CWE 2210373.03r

Subject: Revised Response to DSD-Geology Review Comments, Project Issues Report 1099348, Proposed Single-Family Residence, APN 346-831-44, Ruelle Nicole, La Jolla, California

References: 1) City of San Diego, DSD Geology Review Comments, Project Issues Report 1099348, dated October 11, 2023.
2) Sebastian Mariscal Studio, Architectural Plans, Hermann House, 2538 Ruelle Nicole, La Jolla, CA 92037, dated August 8, 2023.
3) K&S Engineering, Inc., Conceptual Grading and BMP Plans, Hermann House, Lot 25 Montoro, undated.
4) Christian Wheeler Engineering, Report of Preliminary Geotechnical Investigation, CWE 2210373.02, April 17, 2023.

c:\users\drussell\desktop\22210373.02 stability\b-b' proposed block.pl2 Run By: DRR 12/20/2023 05:12PM

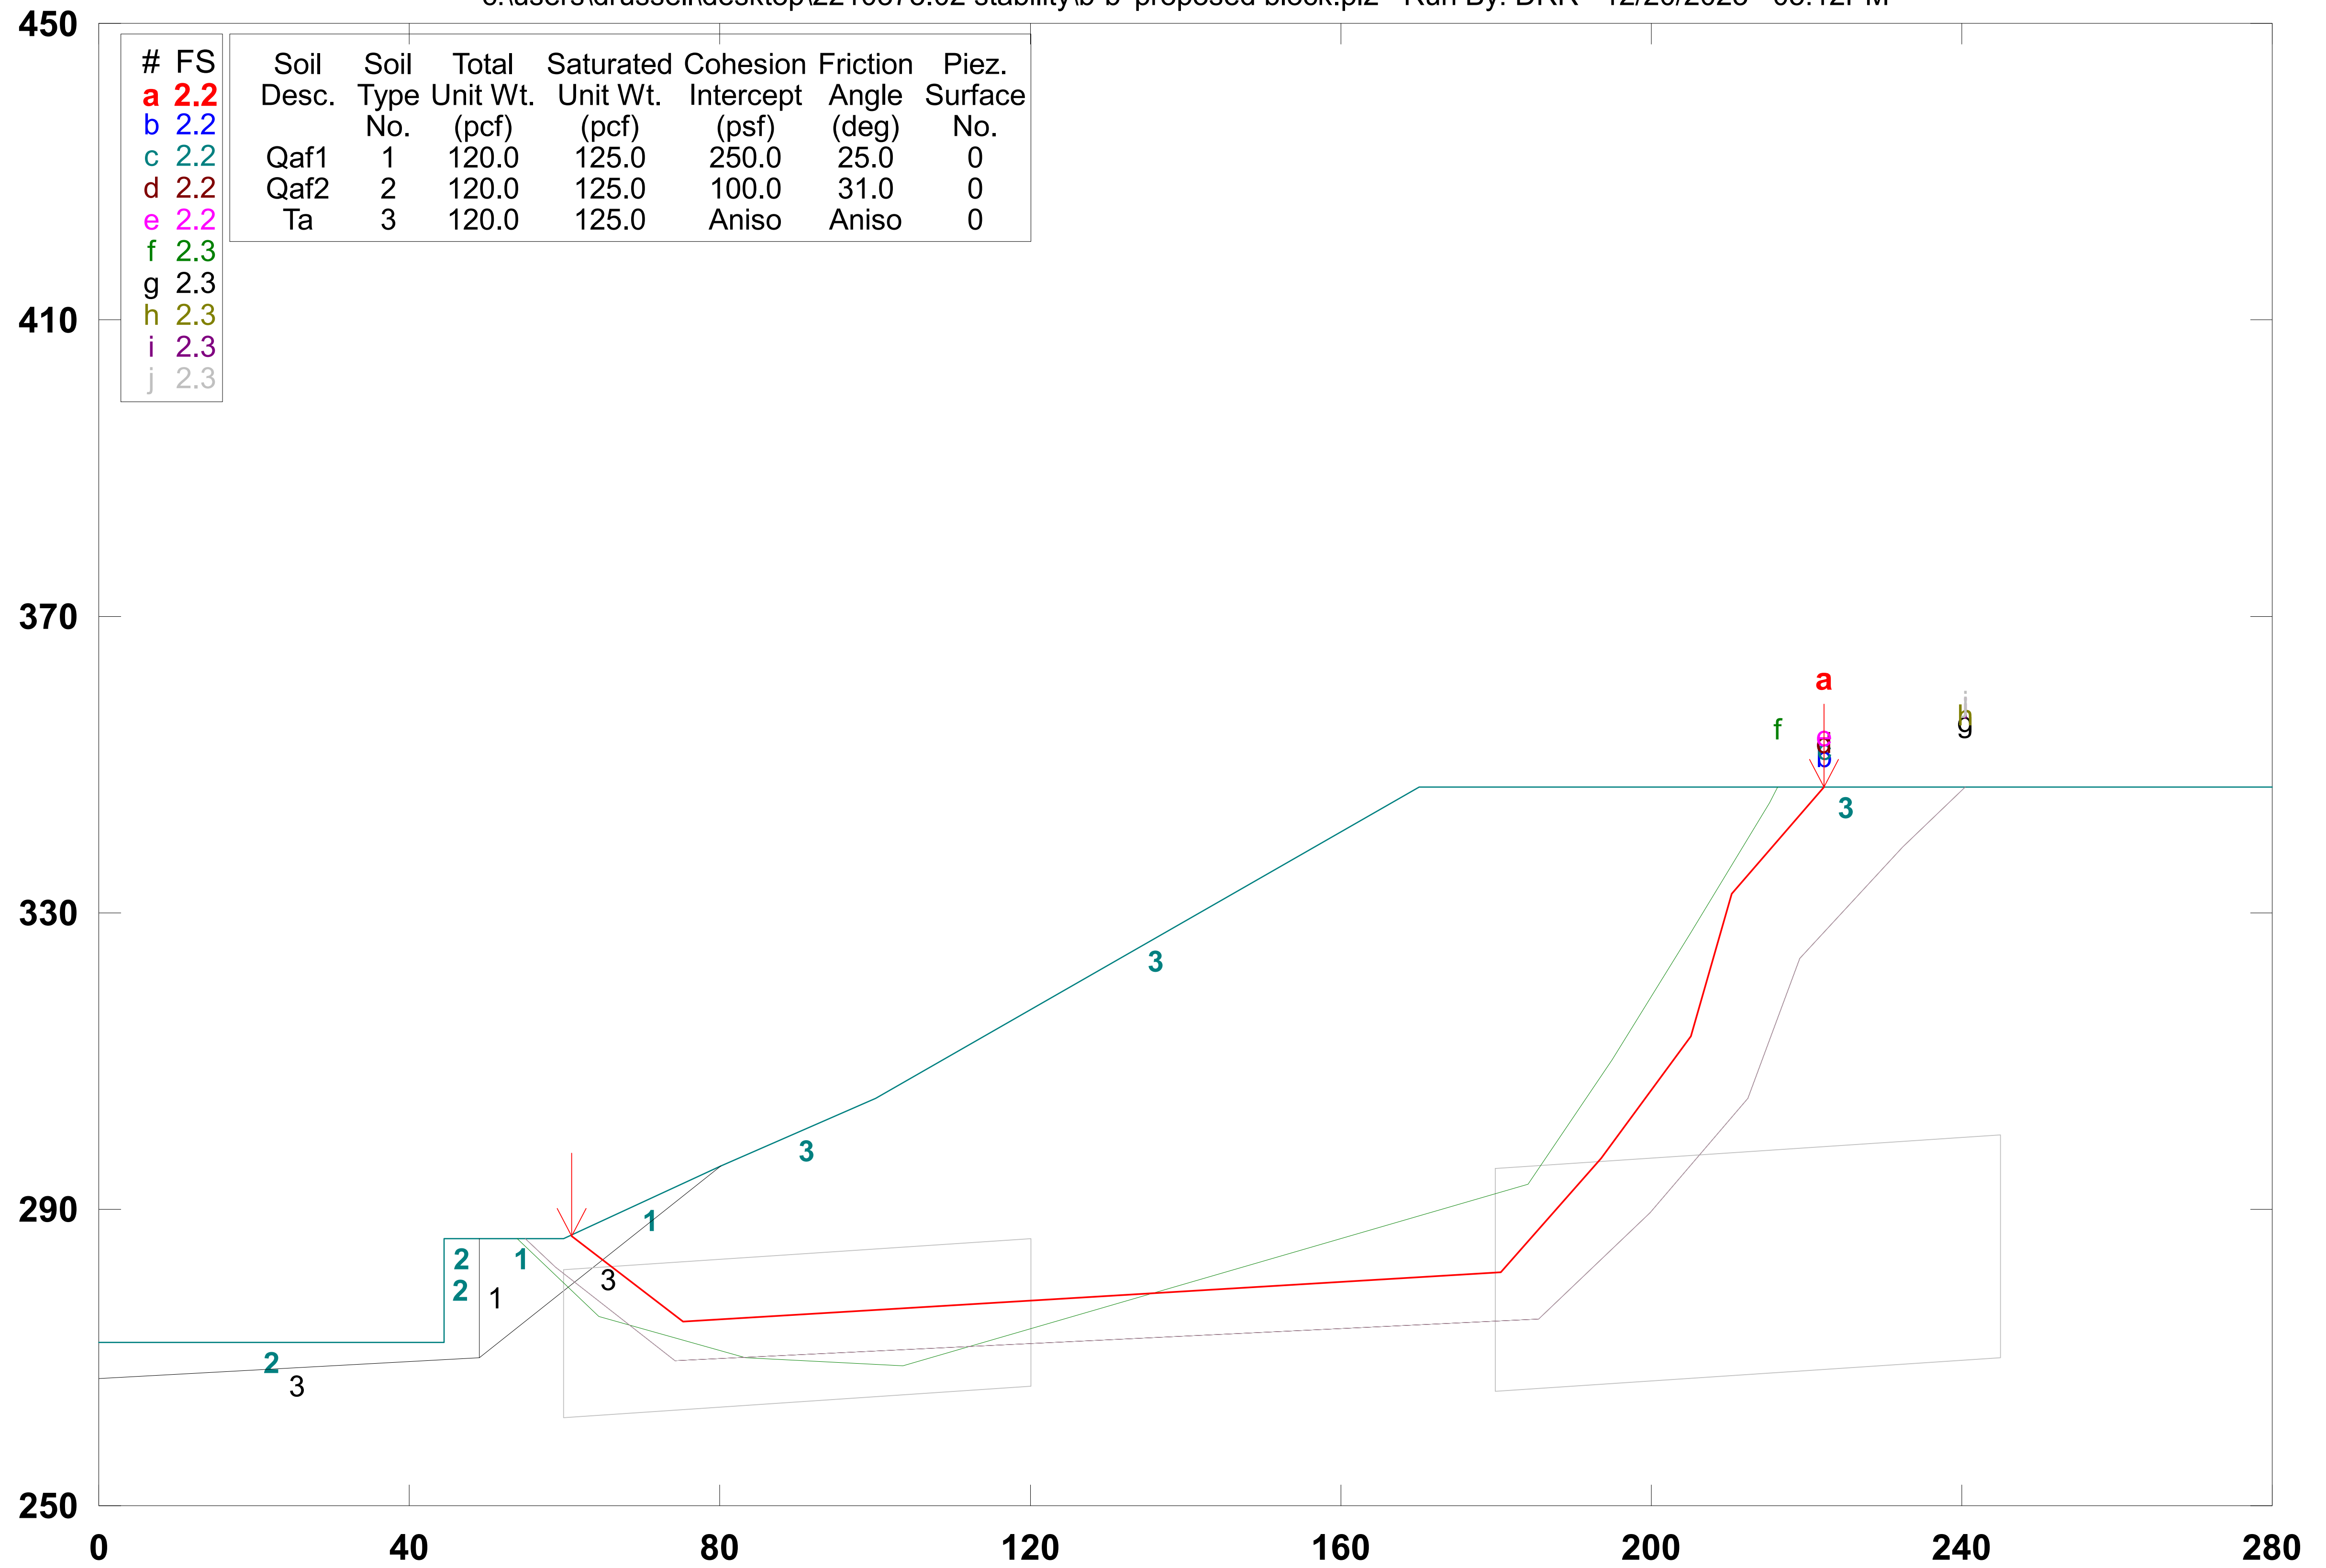
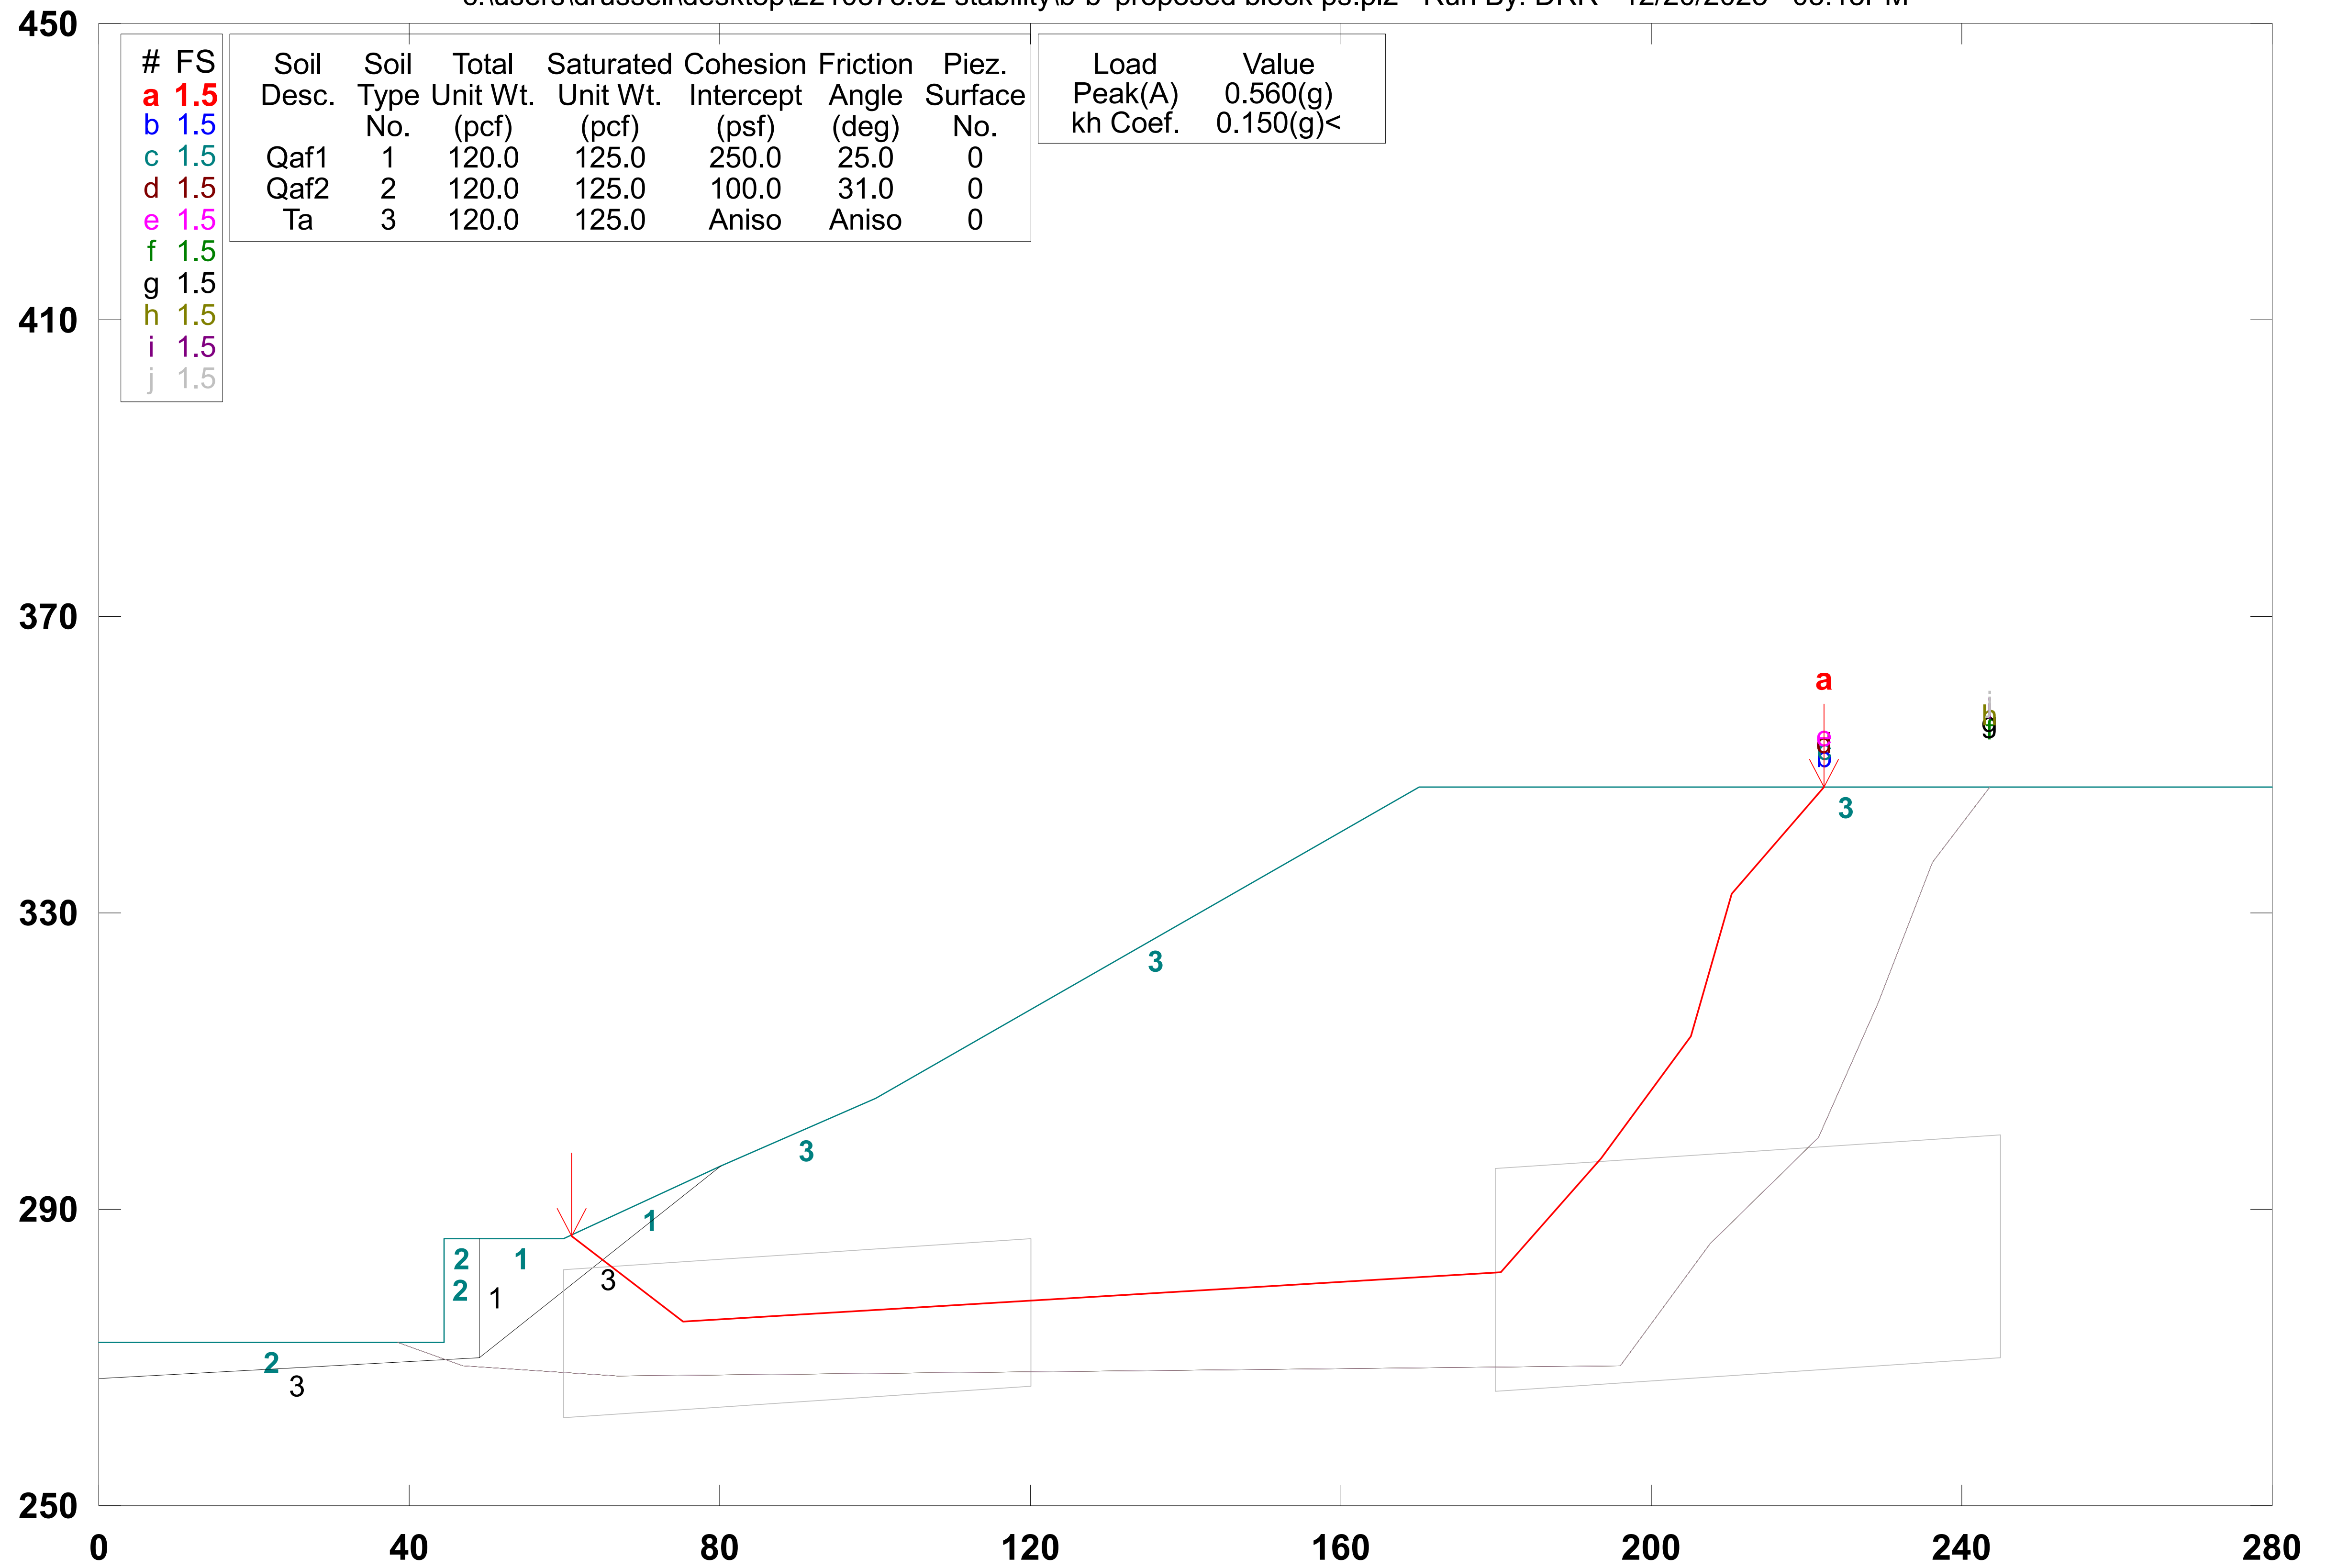
City Comment 00021: Consider providing slope stability analysis of the eastern slope. Where direct observation geologic is not possible utilize conservative shear strength parameters and geologic conditions. Additional analysis and updated geologic cross-sections may be necessary.

CWE Response: Appendix A of this report presents the results of our stability analyses of the existing slope to the east of the proposed residence. The results of these analyses, which were performed using the same parameters included in the analyses presented in our referenced geotechnical report, indicate that the existing slope to the east of the proposed residence (see Plate No. 3 of this report) will demonstrate minimum factors-of-safety against static and pseudo-static failure of 1.7 and 1.3, respectively. These values are in excess of the minimums that are generally considered to be stable of 1.5 and 1.1 for static and pseudo-static analyses, respectively.
